▲ = Revised January 2001

Exhaust Manifolds, Risers and Exhaust Elbows

▲ New Gaskets

Fastener Torque Change

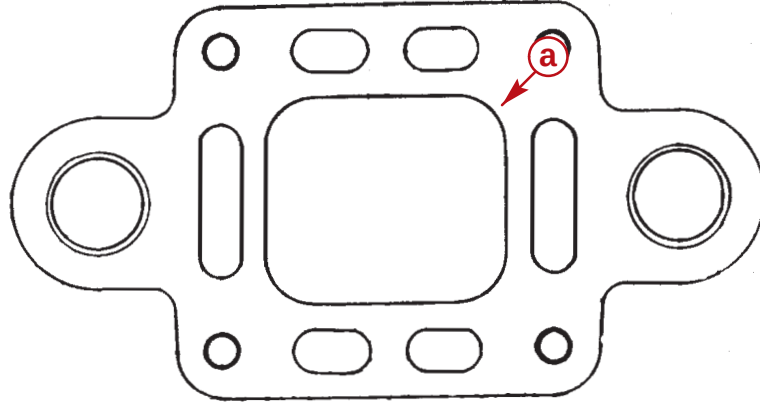
33 lb-ft (45 Nm). Use this new torque on all fasteners when installing exhaust elbows or risers onto exhaust manifolds.
